December 13, 1989  
LD-89-140

Subject: Revision to Organization Amendment

COMBUSTIGN ENGINEERING, INC.  
WINDSOR NUCLEAR FUEL MANUFACTURING FACILITY  
REVISION TO REQUEST FOR LICENSE AMENDMENT  
LIST OF AFFECTED PAGES

WINDSOR FUEL MANUFACTURING FACILITY  
REQUEST FOR LICENSE AMENDMENT

**FIGURE 3.1.1**  
**WINDSOR FUEL MANUFACTURING FACILITY**  
**AND**  
**PRODUCT DEVELOPMENT**  
**ORGANIZATION STRUCTURE**

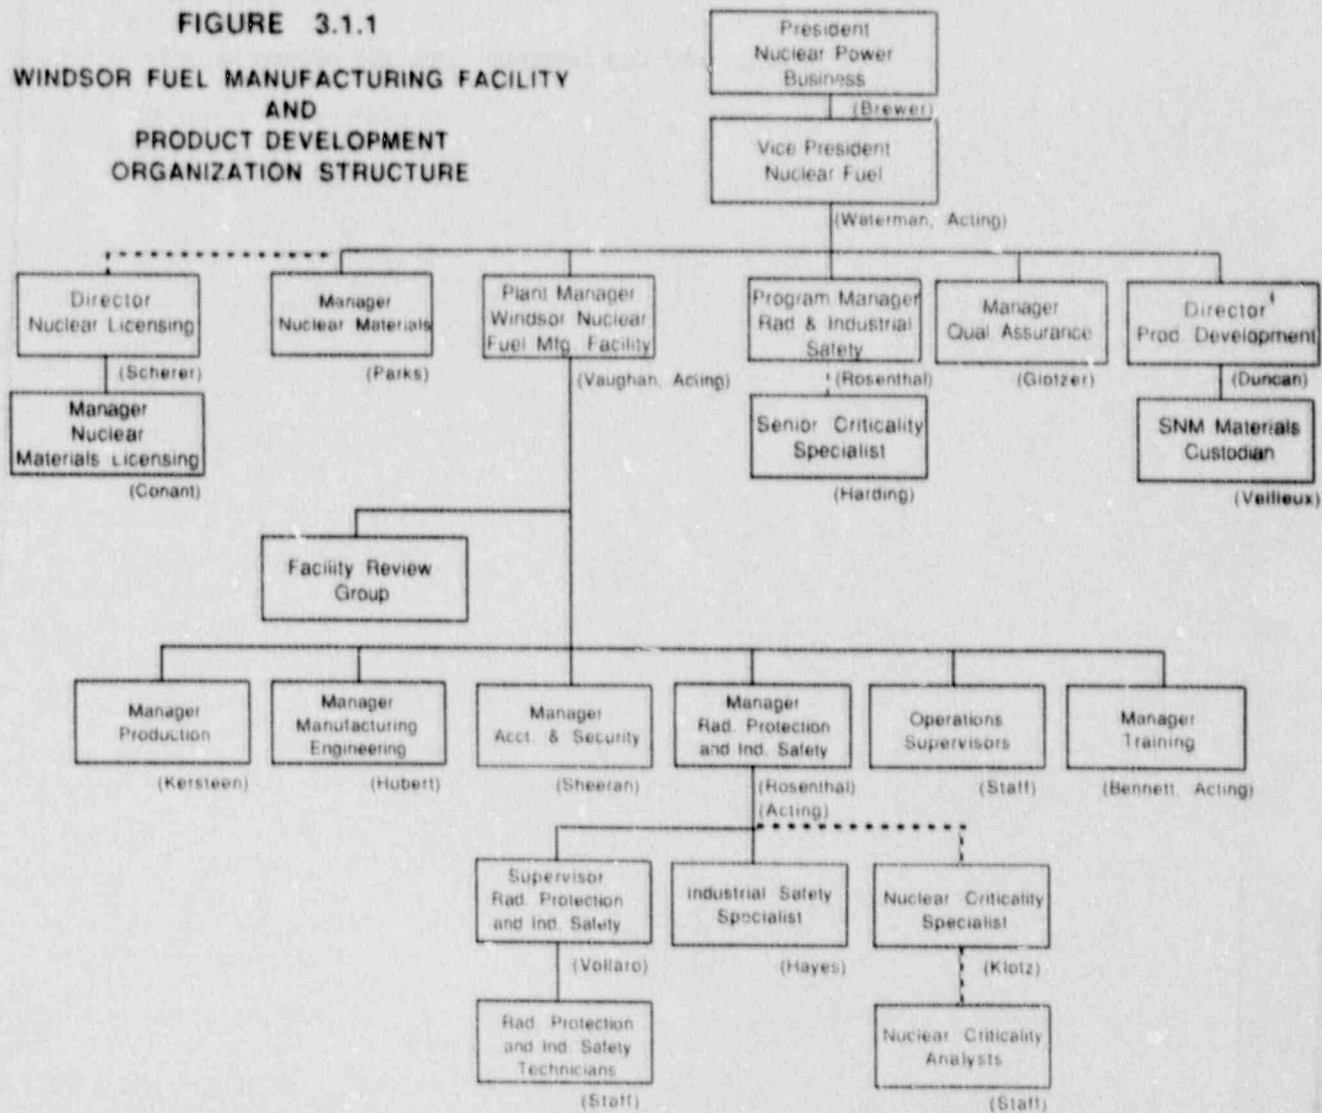
Combustion Engineering requests that the application for license (SNM-1067) for the Windsor Fuel Manufacturing Facility be amended to reflect changes which have been made to the organization structure. Changes are denoted by a bar in the right hand margin of each affected page. The changes provided herein revise selected pages from our Amendment Request dated December 11, 1989 and are being submitted in response to NRC staff comments.
